QUAD CITIES NUCLEAR POWER STATION, UNIT 1

AMENDMENT TO FACILITY OPERATING LICENSE

Amendment No. 149
License No. DPR-29

QUAD CITIES NUCLEAR POWER STATION, UNIT 2

Figure 4.C-2

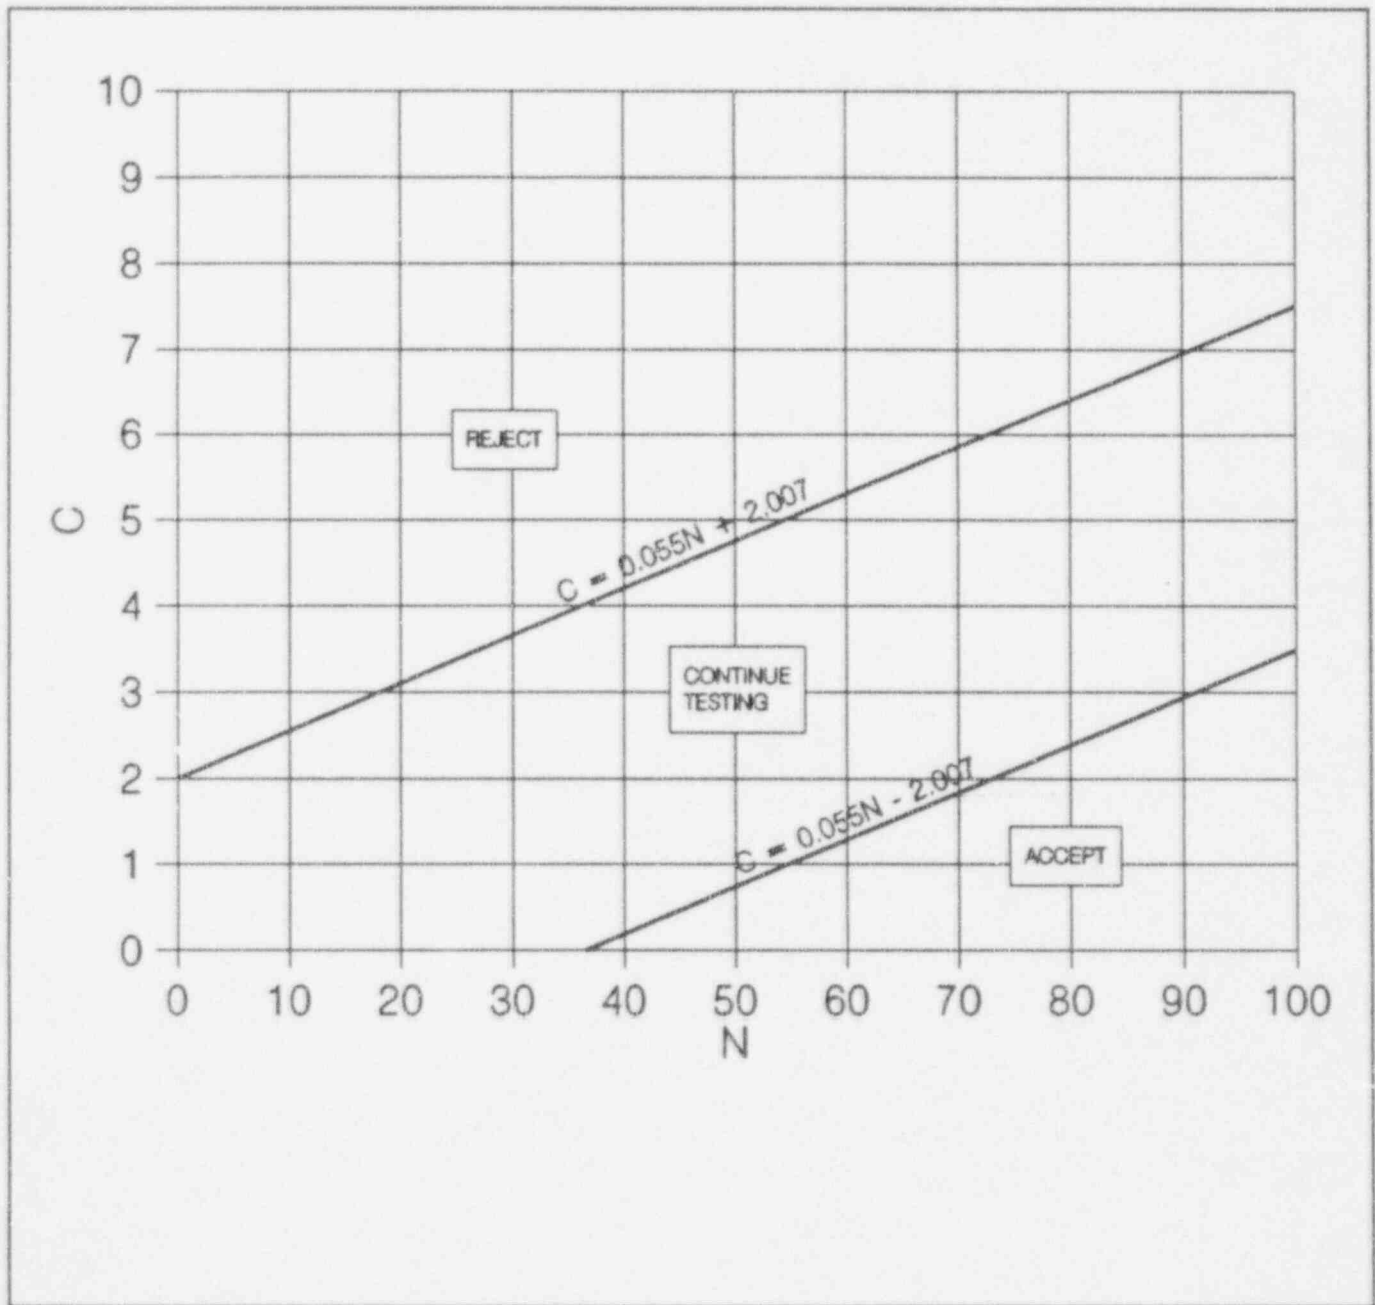
- a. At least 10% of the total of each type of snubber shall be functionally tested either in-place or in a bench test. For each snubber of a type that does not meet the functional test acceptance criteria of Specification 4.6.1.6, an additional 10% of that type of snubber shall be functionally tested until no more failures are found or until all snubbers of that type have been functionally tested; or
- b. A representative sample of each type of snubber shall be functionally tested, in accordance with Figure 4.6-2. "C" is the total number of snubbers of a type found not meeting the acceptance requirements of Specification 4.6.1.6. The cumulative number of snubbers of a type tested is denoted by "N". At the end of each day's testing, the new values of "N" and "C" (previous day's total plus current day's increments) shall be plotted on Figure 4.6-2.

If at any time the point plotted falls on or above the "Reject" line, all snubbers of that type shall be functionally tested. If at any time the point plotted falls on or below the "Accept" line, testing of snubbers of that type may be terminated. When the point plotted lies in the "Continue Testing" region, additional snubbers of that type shall be tested until the point falls in the "Accept" region or the "Reject" region, or all the snubbers of that type have been tested. Testing equipment failure during functional testing may invalidate that day's testing and allow that day's testing to resume anew at a later time, providing all snubbers tested with the failed equipment during the day of equipment failure are retested; or

1. Functionally test 10% of a type of snubber with an additional 10% tested for each functional testing failure, or
2. Functionally test a sample size and determine sample acceptance or rejection using Figure 4.6-2, or

Figure 4.6-2 was developed using "Wald's Sequential Probability Ratio Plan" as described in "Quality Control and Industrial Statistics" by Acheson J. Duncan.

Figure 4.6-2

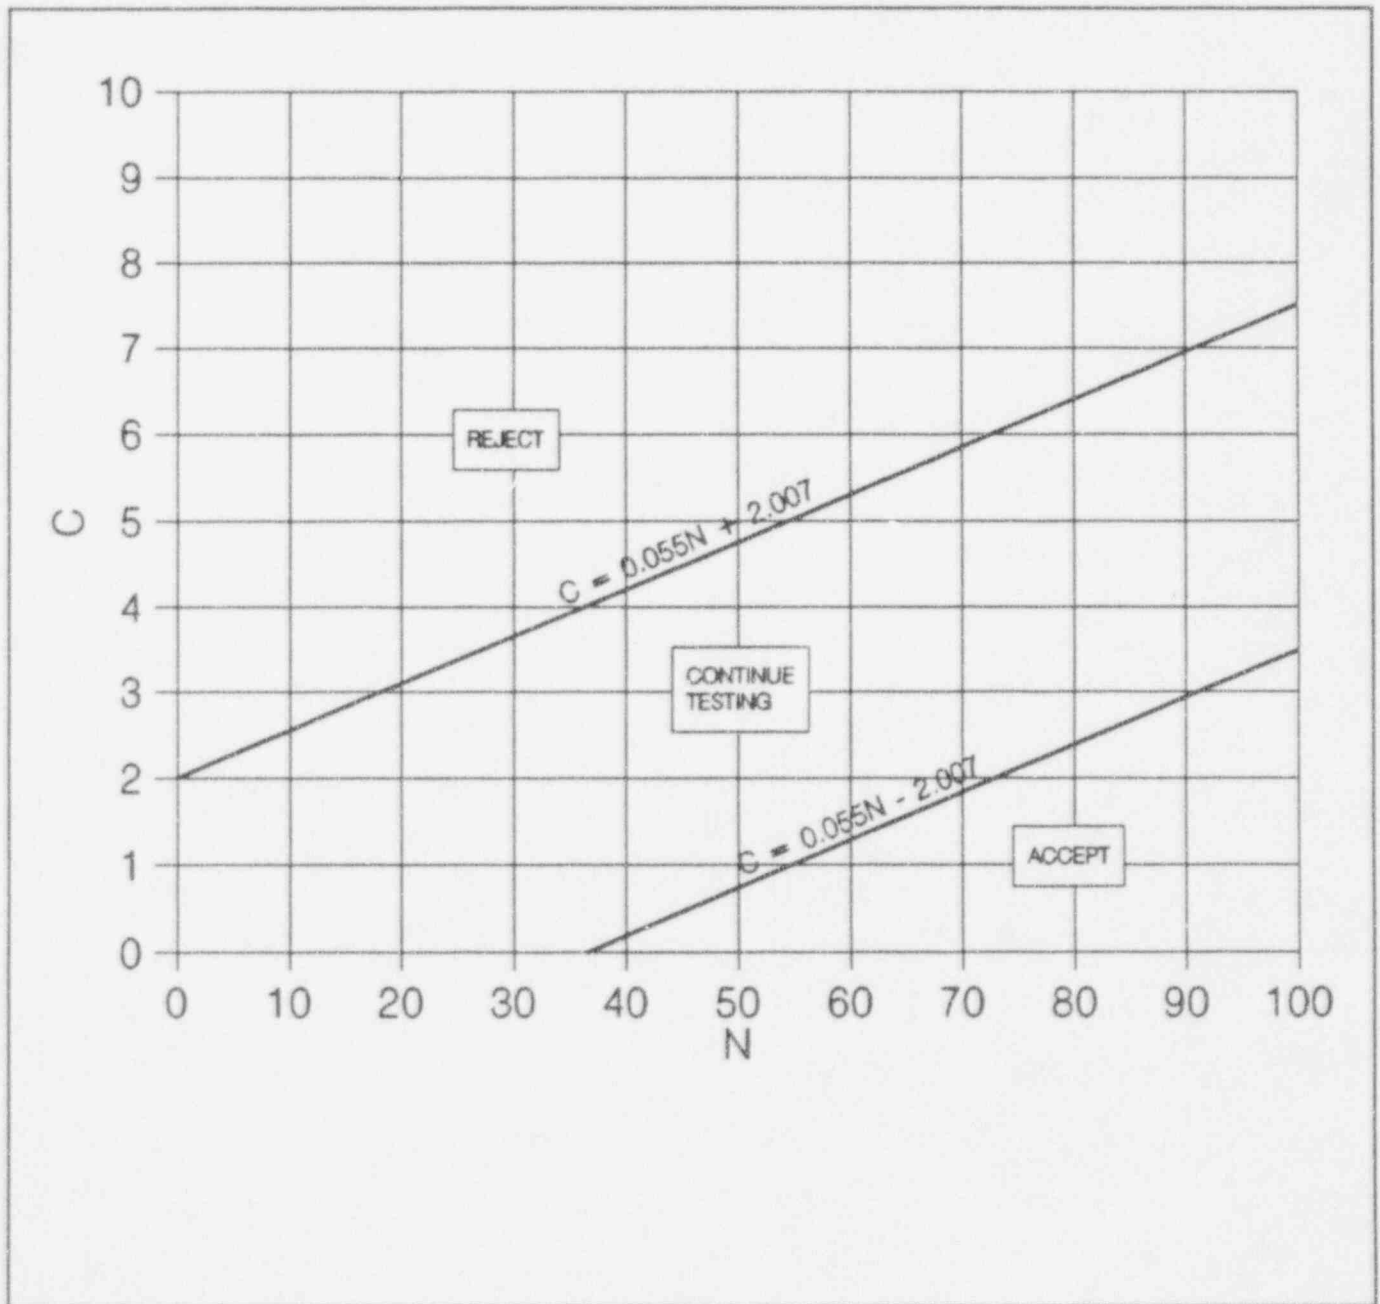
- a. At least 10% of the total of each type of snubber shall be functionally tested either in-place or in a bench test. For each snubber of a type that does not meet the functional test acceptance criteria of Specification 4.6.1.6, an additional 10% of that type of snubber shall be functionally tested until no more failures are found or until all snubbers of that type have been functionally tested; or
- b. A representative sample of each type of snubber shall be functionally tested, in accordance with Figure 4.6-2. "C" is the total number of snubbers of a type found not meeting the acceptance requirements of Specification 4.6.1.6. The cumulative number of snubbers of a type tested is denoted by "N". At the end of each day's testing, the new values of "N" and "C" (previous day's total plus current day's increments) shall be plotted on Figure 4.6-2.

If at any time the point plotted falls on or above the "Reject" line, all snubbers of that type shall be functionally tested. If at any time the point plotted falls on or below the "Accept" line, testing of snubbers of that type may be terminated. When the point plotted lies in the "Continue Testing" region, additional snubbers of that type shall be tested until the point falls in the "Accept" region or the "Reject" region, or all the snubbers of that type have been tested. Testing equipment failure during functional testing may invalidate that day's testing and allow that day's testing to resume anew at a later time, providing all snubbers tested with the failed equipment during the day of equipment failure are retested; or

1. Functionally test 10% of a type of snubber with an additional 10% tested for each functional testing failure, or
2. Functionally test a sample size and determine sample acceptance or rejection using Figure 4.6-2, or

Figure 4.6-2 was developed using "Wald's Sequential Probability Ratio Plan" as described in "Quality Control and Industrial Statistics" by Acheson J. Duncan.
